**BRAKE AND CLUTCH CONTROL HANDLEVER CHANGES**

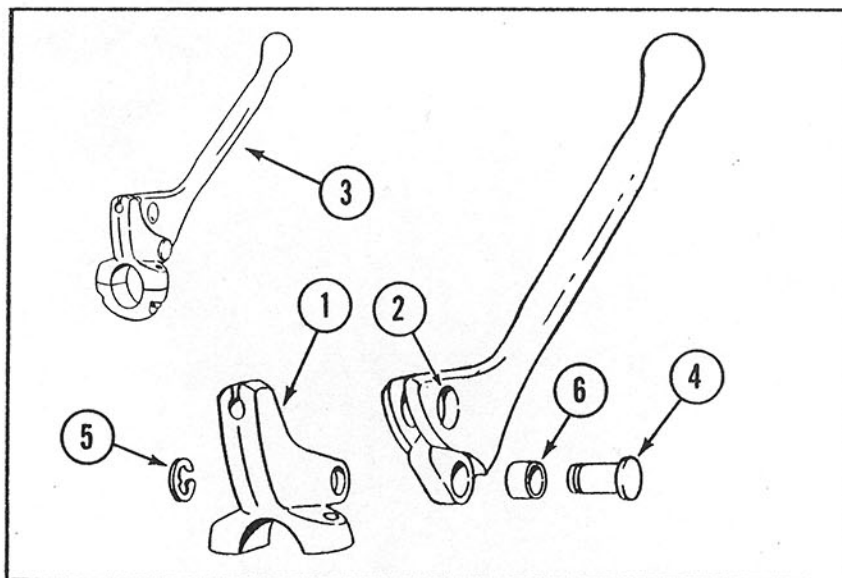
A quantity of early 1965 motorcycles are equipped with clutch or brake control handlevers having a 15/32 dia. pivot pin and the same size holes in the handlever and bracket. For late 1965 production, these parts were changed to utilize a smaller 13/32 dia. pivot pin with corresponding size holes in handlever and bracket. The only exception is the Sportster clutch side handlever which will be changed at a later date.

When a control lever bracket (see illustration, Item 1) with large 15/32 diameter pin hole or large diameter pivot pin (Item 2) and mating snap ring (Item 5) require replacement, order handlever bracket conversion kit under following part numbers:

Above kits contain the latest bracket (Item 1) having a smaller 13/32 dia. hole as used with latest handlevers. A bushing (Item 6) is included, which fits into larger hole in your old lever (Item 2) to accommodate a smaller pivot pin (Item 4) and retaining ring (Item 5), also included in kits.

When a control lever (Item 2) with large pivot pin hole requires replacement, order entire handlever and bracket assembly (Item 3) under following part numbers:

45042-65 Bracket Kit for Electra-Glide and Pacer-Scat Brake or Clutch Handlevers or Sportster Brake Handlever.

38610-65 Bracket Kit for Sportster Clutch Handlever.

45002-65 Handlever Assembly for Electra-Glide, Sportster and Pacer-Scat Brake or Electra-Glide and Pacer-Scat Clutch Handlever.

38604-65 Handlever Assembly for Sportster Clutch Handlever.
